Technical Service Information

ZF-4HP-22/24

REPEATED LEAK FROM BELL HOUSING AREA

Figure 1

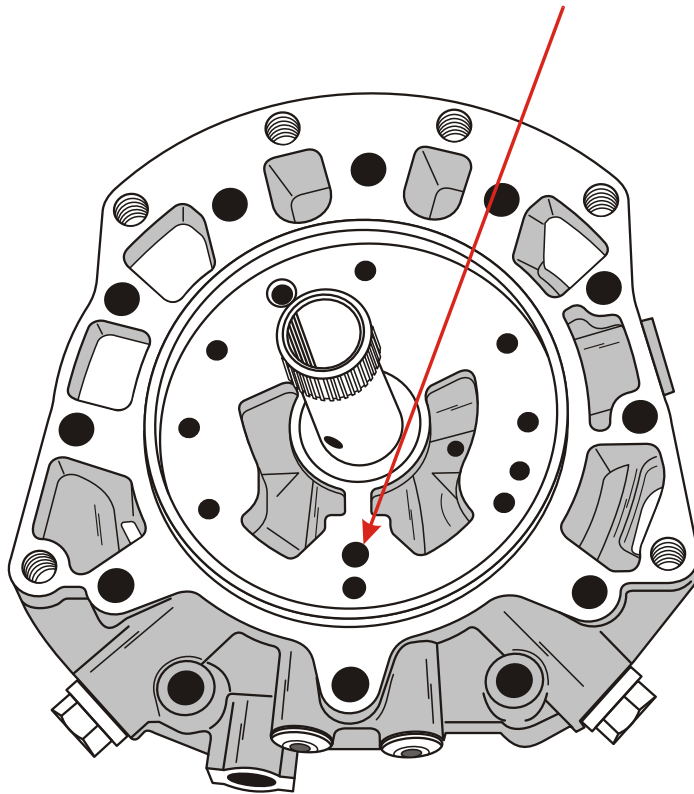
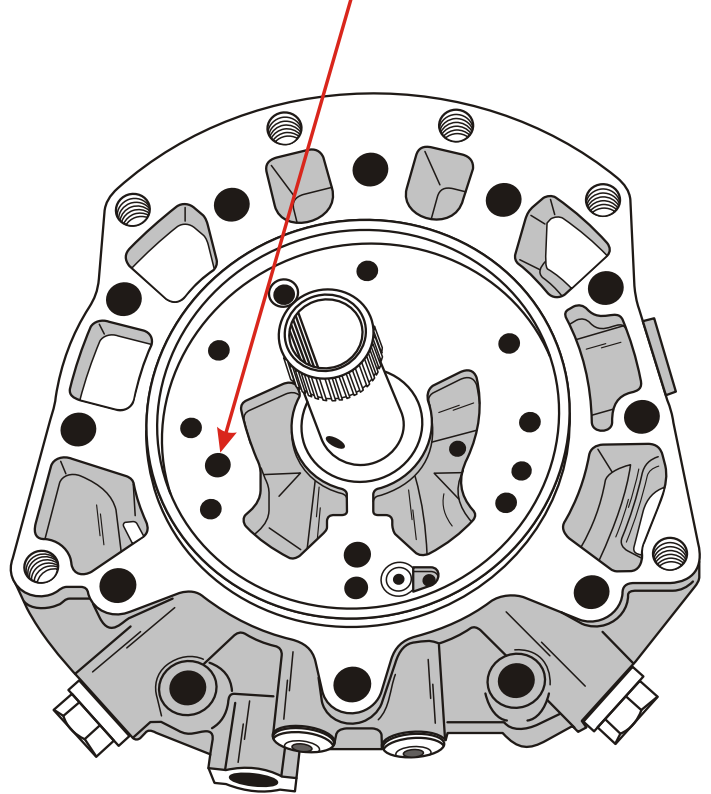
- COMPLAINT:** Repeated leakage of transmission fluid, coming from the bell housing area on any vehicle equipped with the ZF-4HP-22 or 4HP-24 transmission. This usually occurs after rebuild coupled with pump parts replacement that was necessary.

- CAUSE:** Beginning in the 1989 model year, ZF implemented a running change to the pump body and pump cover on both the 4HP-22 and the 4HP-24 transmissions. This change was made to increase the durability of the converter bushing with increased lubrication to this area. This change however, created the possibility of mis-matching parts that are not compatible. The 1st design pump body and cover has the drain back hole located at the 6 O'clock position and the drain back passage was moved to the 3 O'clock position in the 2nd design pump body and cover, as shown in Figure 1. Installing 2nd design pump body with 1st design pump cover will completely block the drain back passage and the repeated leakage will occur. Installing the 1st design pump body with 2nd design pump cover will function, but you will now be faced with the possibility of premature converter bushing failure.

- CORRECTION:** To eliminate both conditions, always install the 2nd design pump body, matched with the 2nd design pump cover, as shown in Figure 1.
